HISTORIC AND DESIGN REVIEW COMMISSION

September 21, 2022

HDRC CASE NO: 2022-389
ADDRESS: 509 DELAWARE
LEGAL DESCRIPTION: NCB 656 BLK W 1-2 OF 11 LOT E 149.61 FT OF 5 & 6
ZONING: IDZ-3, H
CITY COUNCIL DIST.: 2
LANDMARK: Achtzehn House
APPLICANT: Thomas Glendenning/BRIGHT LAKES REAL ESTATE LLC
OWNER: Thomas Glendenning/BRIGHT LAKES REAL ESTATE LLC
TYPE OF WORK: Demolition of a landmark, approval of a site plan
APPLICATION RECEIVED: July 19, 2022
60-DAY REVIEW: Not applicable due to City Council Emergency Orders
CASE MANAGER: Edward Hall

The applicant is requesting a Certificate of Appropriateness for approval to demolish the historic landmark at 509 Delaware, commonly known as the Achtzehn House.

**PROPOSED SITE
PLAN**

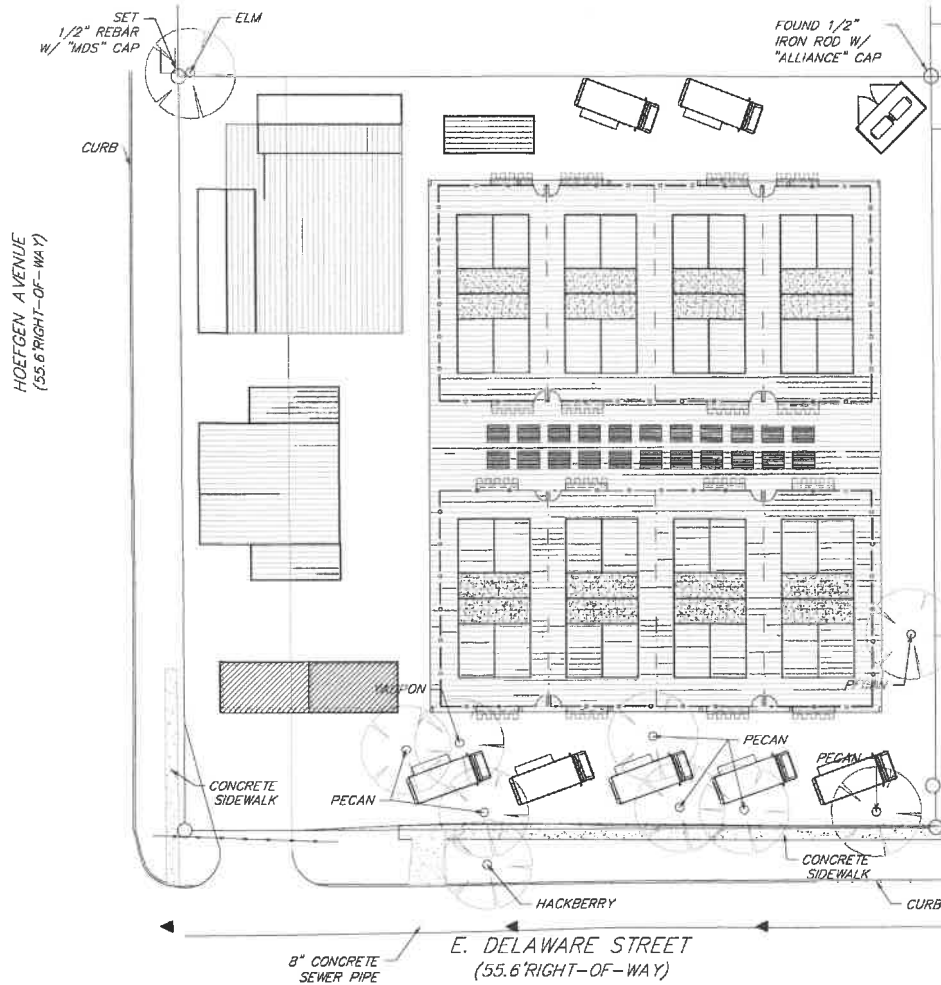
- h. REPLACEMENT PLANS – The applicant has proposed to install a food truck park and has provided a site plan noting the construction of buildings, dumpster locations and outdoor seating. Generally, staff finds a commercial structure on site would be appropriate; however, staff finds that additional information should be provided, such as information regarding site paving, on-site parking and building setbacks from the right of way.

- i. That the applicant submit a detailed salvage plan for existing architectural materials. If brick is found to be structurally unsound, staff recommends the applicant consider its reuse for site and paving elements.
- ii. That the applicant submit further developed architectural documents for the proposed replacement food truck park.
